Standard Development Timeline

PRC-024-3 is posted for a 10-day final ballot.

1. **Title:** ~~Generator Frequency and Voltage Protective Relay Settings for Generating Resources~~
2. **Number:** PRC-024-~~23~~
3. **Purpose:** ~~Ensure Generator Owners To set their generator protection ve relays~~ such that generating ~~resource(s) units~~ remain connected during defined frequency and voltage excursions ~~in support of the Bulk Electric System (BES).~~
4. **Applicability:**

Standard PRC-024-23 — ~~Generator~~ Frequency and Voltage Protective ~~Relay~~ Settings for Generating Resources

Figure 1

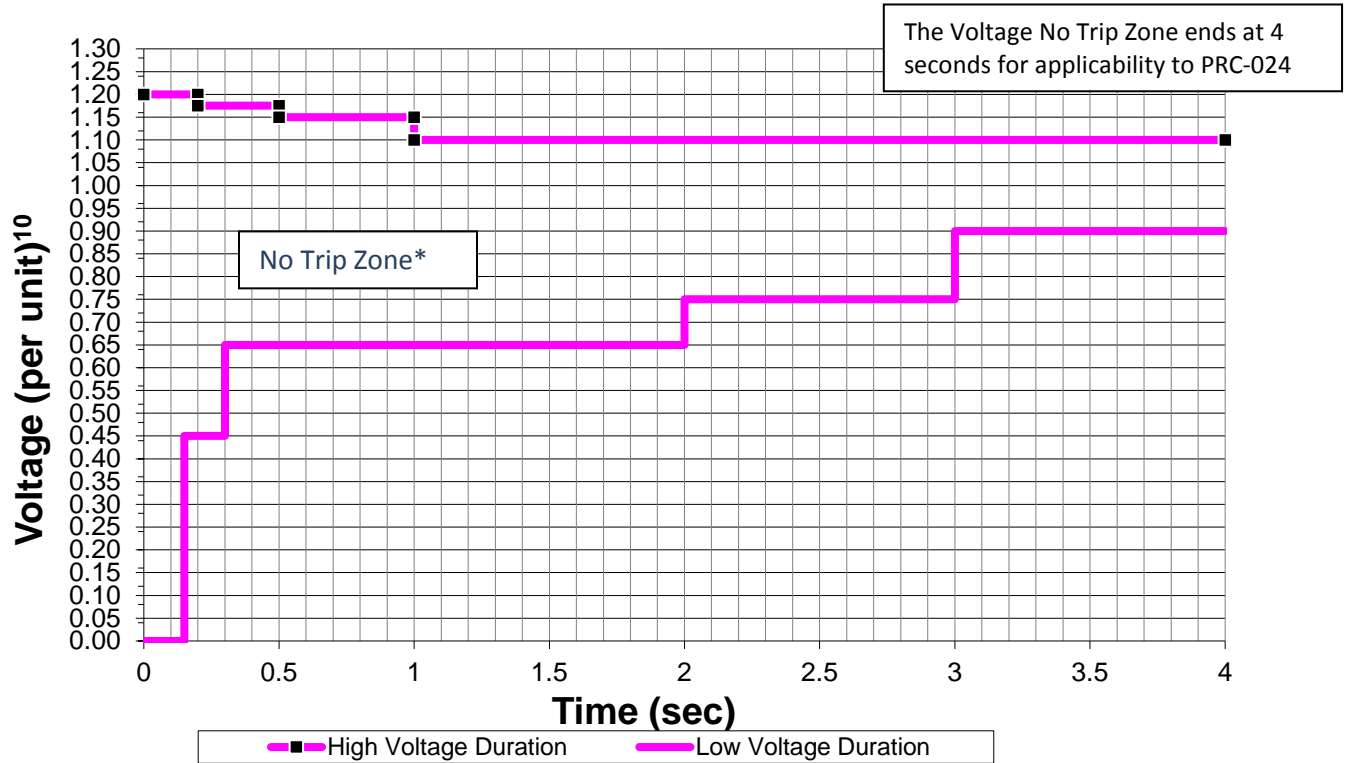
PRC-024 — Attachment 2
(Voltage No-Trip Boundaries – Eastern, Western, and ERCOT Interconnections)

Voltage Boundary Data Points

High Voltage Duration		Low Voltage Duration	
Voltage (pu)	Minimum Time (sec)	Voltage (pu)	Minimum Time (sec)
≥ 1.200	<u>0.00</u>	< 0.45	<u>0.15</u>
≥ 1.175	<u>0.20</u>	< 0.65	<u>0.30</u>
≥ 1.15	<u>0.50</u>	< 0.75	<u>2.00</u>
≥ 1.10	<u>1.00</u>	< 0.90	<u>3.00</u>
< 1.10	<u>4.00</u>	≥ 0.90	<u>4.00</u>

Figure 1

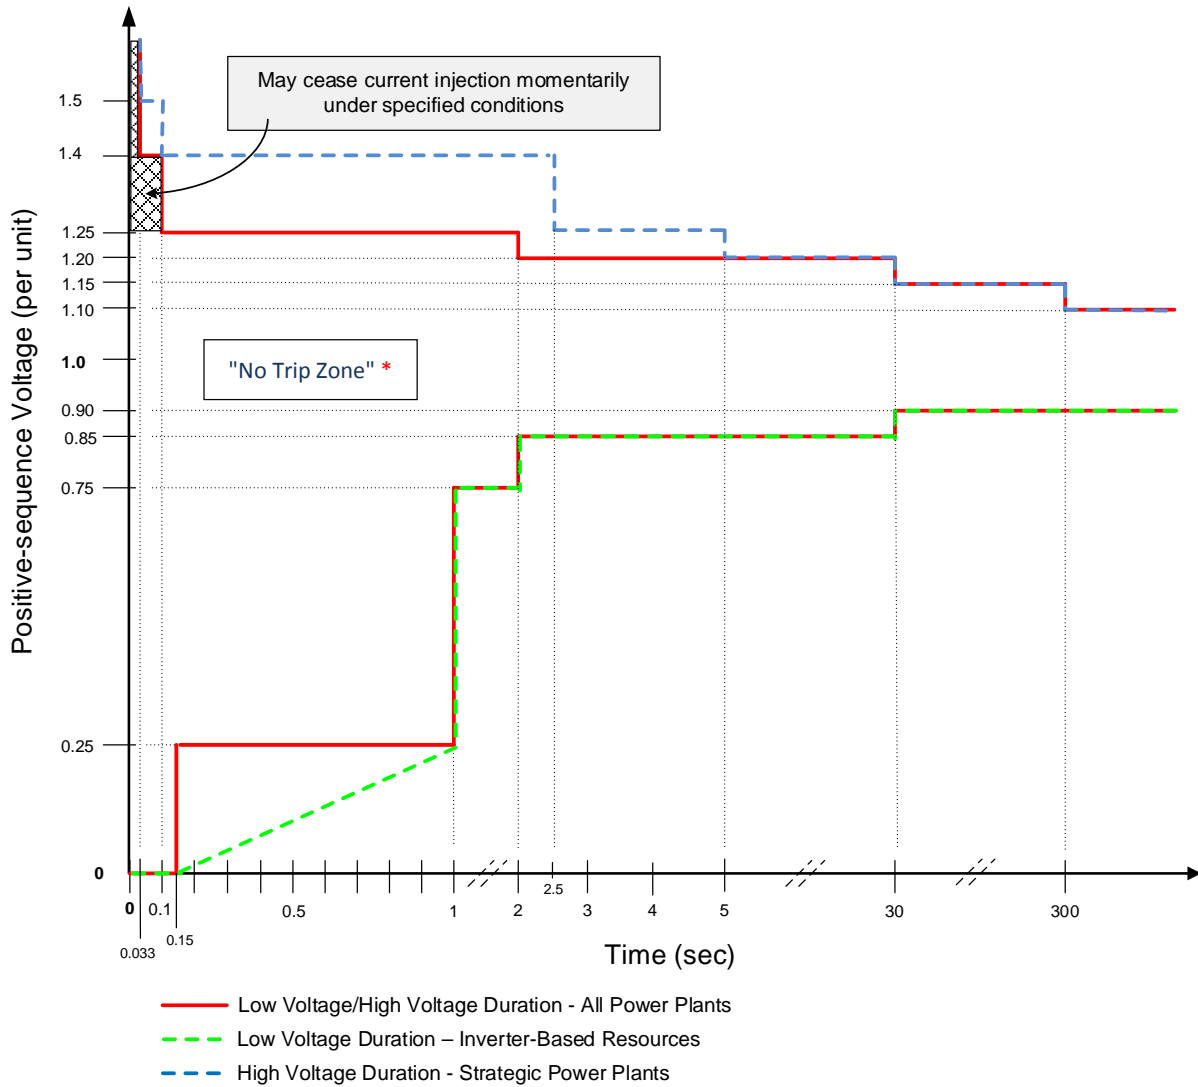
PRC-024— Attachment 2a
(Voltage No-Trip Boundaries – Quebec Interconnection)

<u>High Voltage Duration for all Power Plants</u>		<u>High Voltage Duration for strategic Power Plants</u>	
<u>Voltage (pu)</u>	<u>Minimum Time (sec)</u>	<u>Voltage (pu)</u>	<u>Minimum Time (sec)</u>
<u>---</u>	<u>---</u>	<u>>1.50</u>	<u>0.033</u>
<u>>1.40</u>	<u>0.033</u>	<u>>1.40</u>	<u>0.10</u>
<u>>1.25</u>	<u>0.10</u>	<u>>1.25</u>	<u>2.50</u>
<u>>1.20</u>	<u>2.00</u>	<u>>1.20</u>	<u>5.00</u>
<u>>1.15</u>	<u>30</u>	<u>>1.15</u>	<u>30</u>
<u>>1.10</u>	<u>300</u>	<u>>1.10</u>	<u>300</u>
<u>≤1.10</u>	<u>continuous</u>	<u>≤1.10</u>	<u>continuous</u>

<u>Low Voltage Duration for all Power Plants</u>		<u>Low Voltage Duration for Inverter-Based Resources</u>	
<u>Voltage (pu)</u>	<u>Minimum Time (sec)</u>	<u>Voltage (pu)</u>	<u>Minimum Time (sec)</u>
<u><0.25</u>	<u>0.15</u>	<u><0.25</u>	<u>3.4*V(pu)+0.15</u>
<u><0.75</u>	<u>1.00</u>	<u><0.75</u>	<u>1.00</u>
<u><0.85</u>	<u>2.00</u>	<u><0.85</u>	<u>2.00</u>
<u><0.90</u>	<u>30</u>	<u><0.90</u>	<u>30</u>
<u>≥0.90</u>	<u>continuous</u>	<u>≥0.90</u>	<u>continuous</u>
